REZONING SITE PLAN
 SCALE: 1" = 50'
 DATE: DEC. 29, 2014
 PROJECT: KM27 LINE

PETITION NO: Z-27

ZONING COMMENTS:

Z-27 LYNWOOD DEVELOPMENT GROUP, LLC

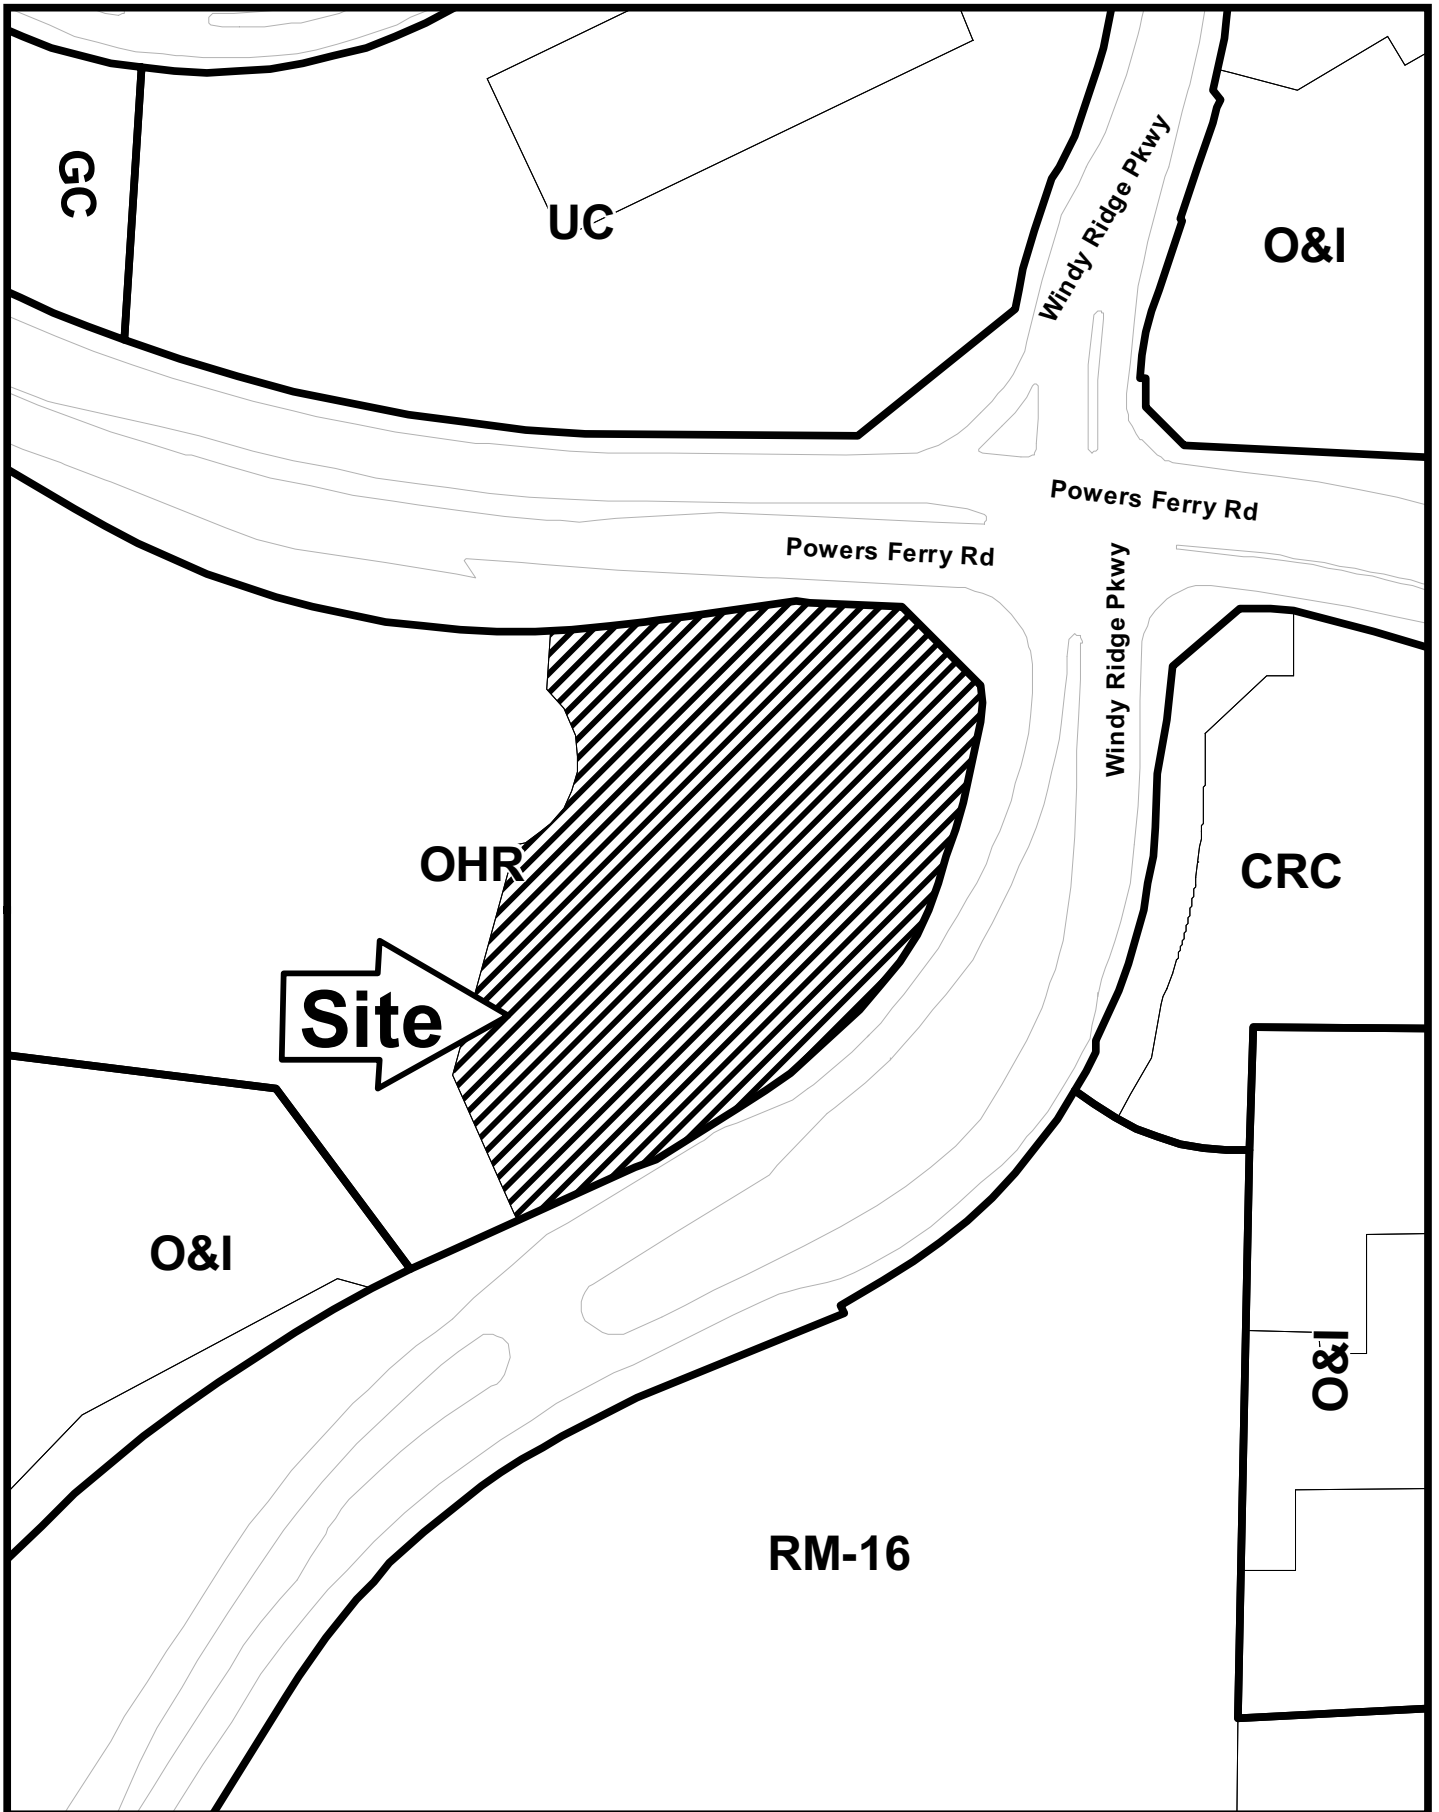
- Provide comprehensive hydrology/stormwater controls to include development of out parcels.
- Submit all proposed site improvements to Plan Review.
- Any **spring activity** uncovered must be addressed by a qualified geotechnical engineer (PE).
- Structural fill _____ must be placed under the direction of a qualified registered Georgia geotechnical engineer (PE).
- Existing facility.
- Project must comply with the Water Quality requirements of the CWA-NPDES-NPS Permit and County Water Quality Ordinance.
- Water Quality/Quantity contributions of the existing lake/pond on site must be continued as baseline conditions into proposed project.
- Calculate and provide % impervious of project site.
- Revisit design; reduce pavement area to reduce runoff and pollution.

- No Stormwater controls shown _____
- Copy of survey is not current – Additional comments may be forthcoming when current site conditions are exposed.
- No site improvements showing on exhibit.
